DOCUMENT 00 91 02 – ADDENDUM NO. 2

PROJECT: A1/A2 Reservoirs and B/C Booster Pump Station Project

ISSUED: January 20, 2021

SHEET
E-3
OF

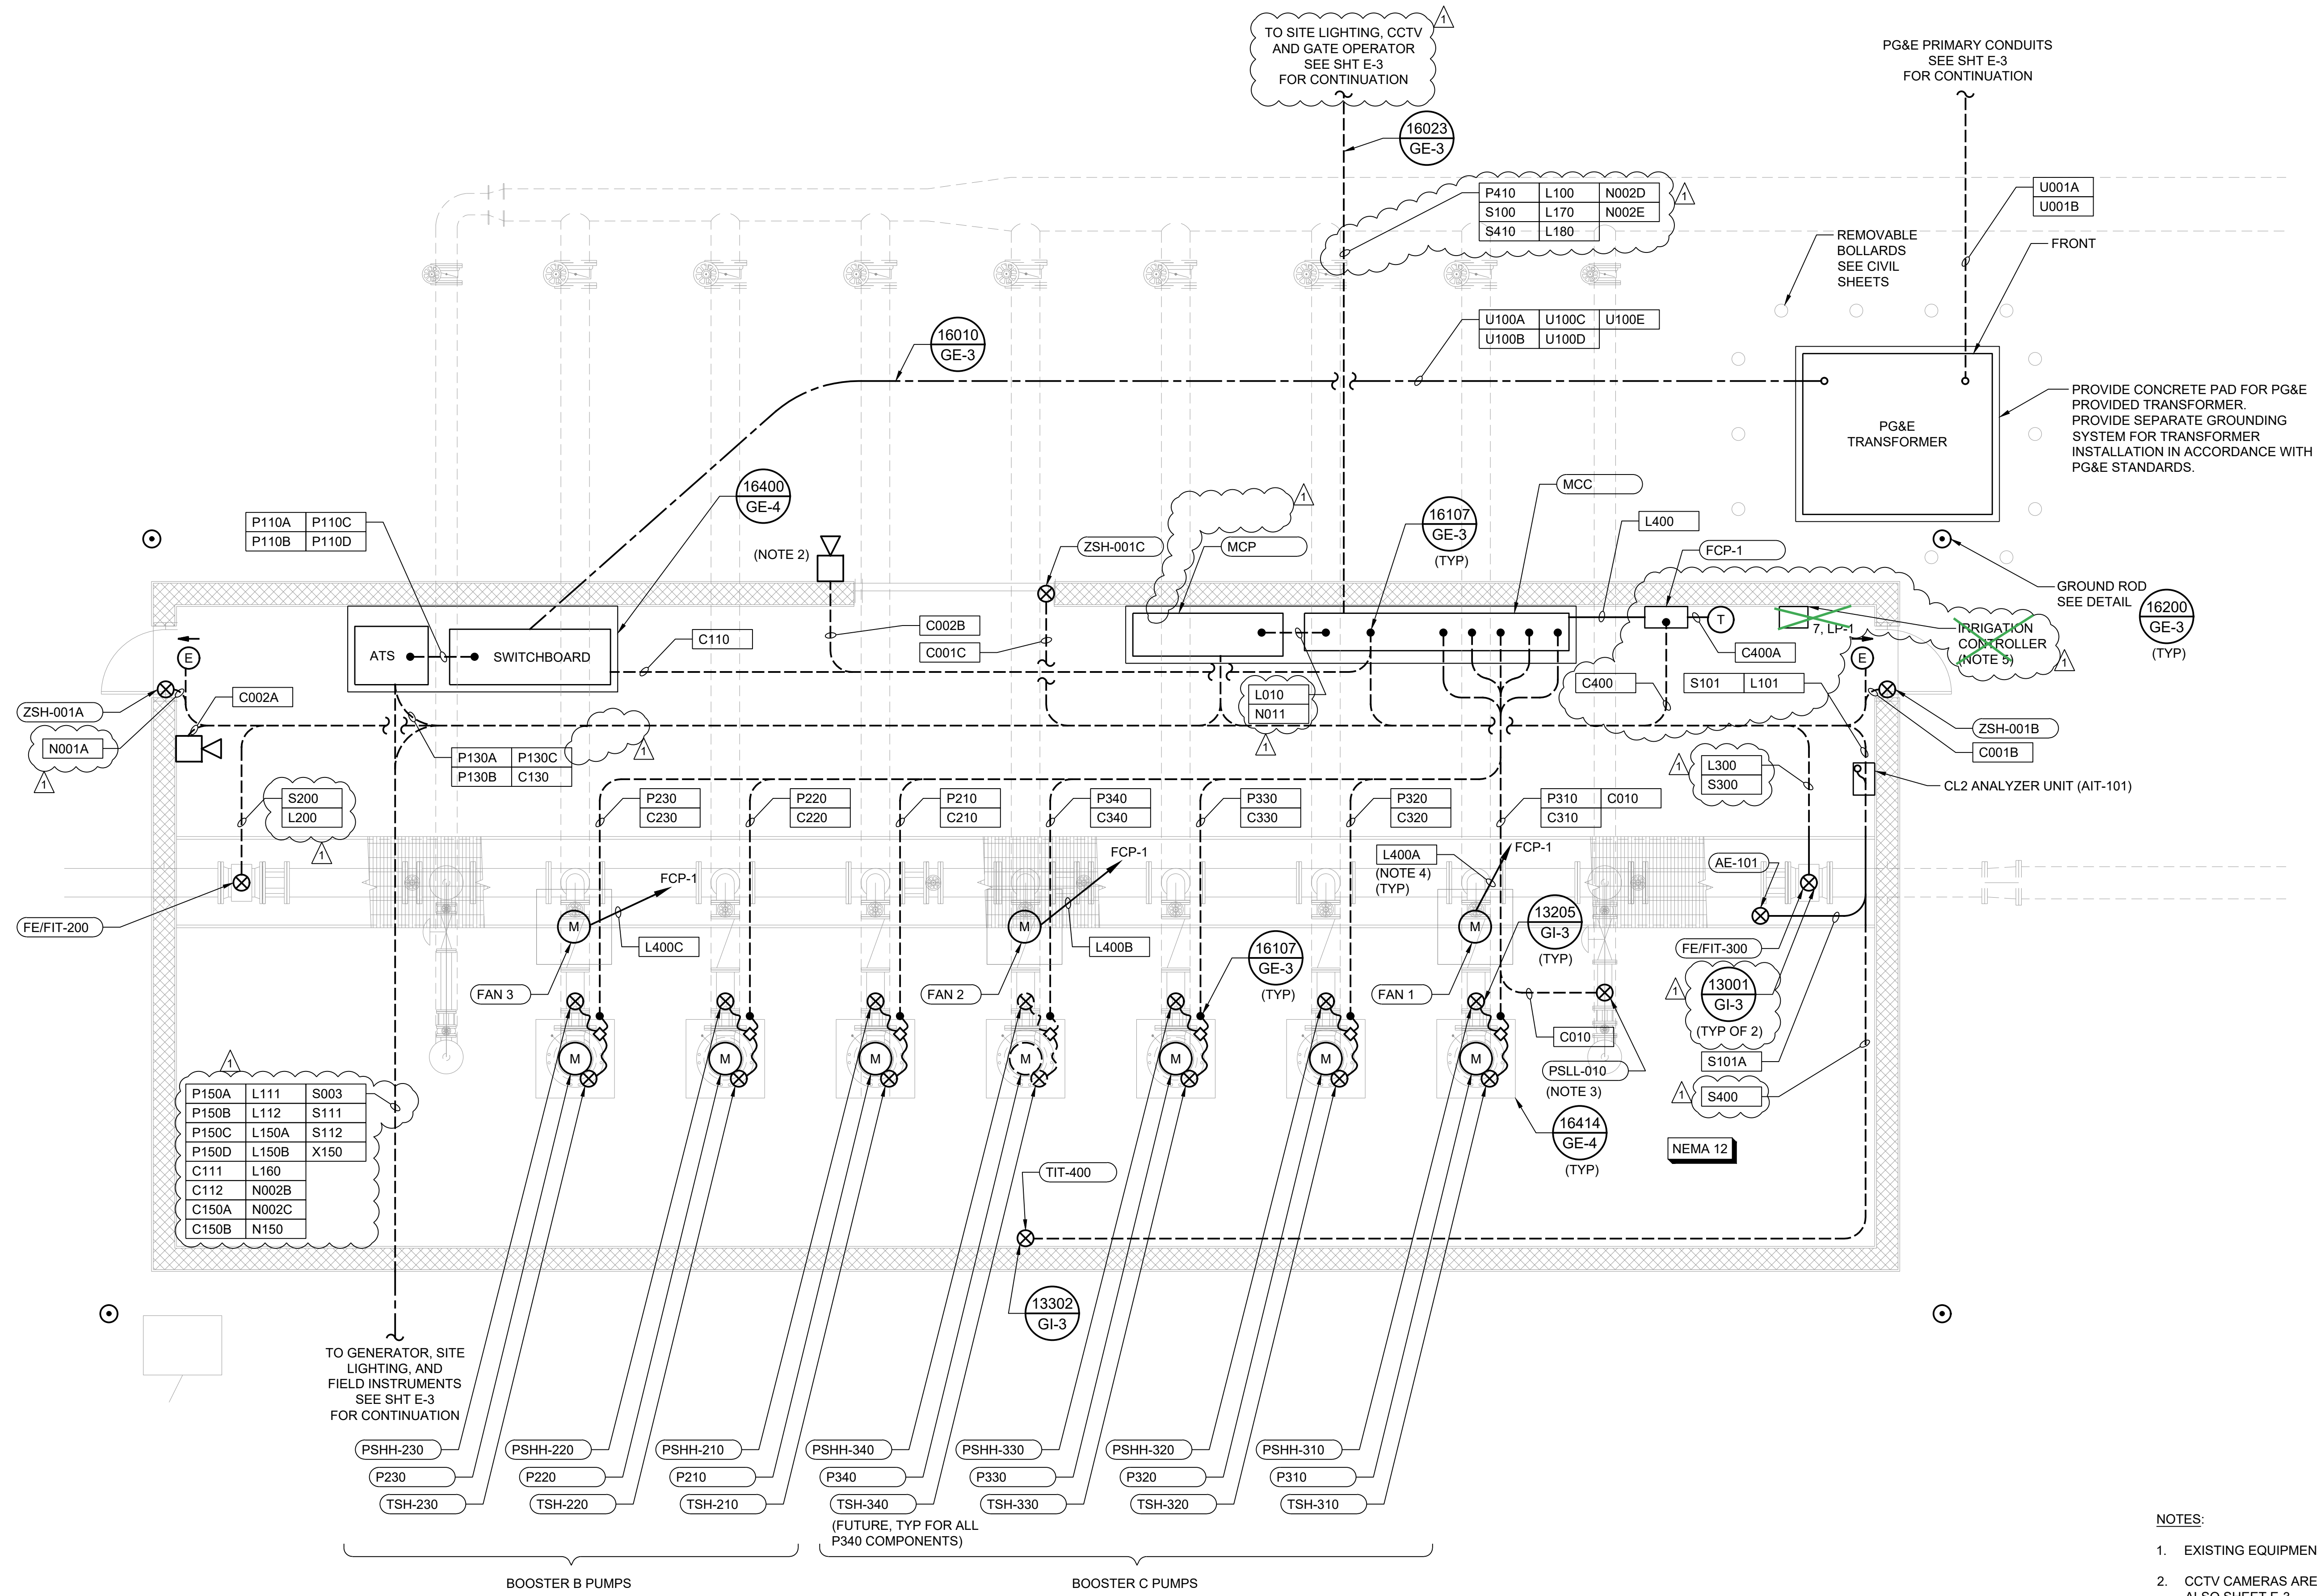
K. Sheets E-3, E-4, S-3, S-4, S-5, S-6 and S-11 are reissued with corrections (attached).
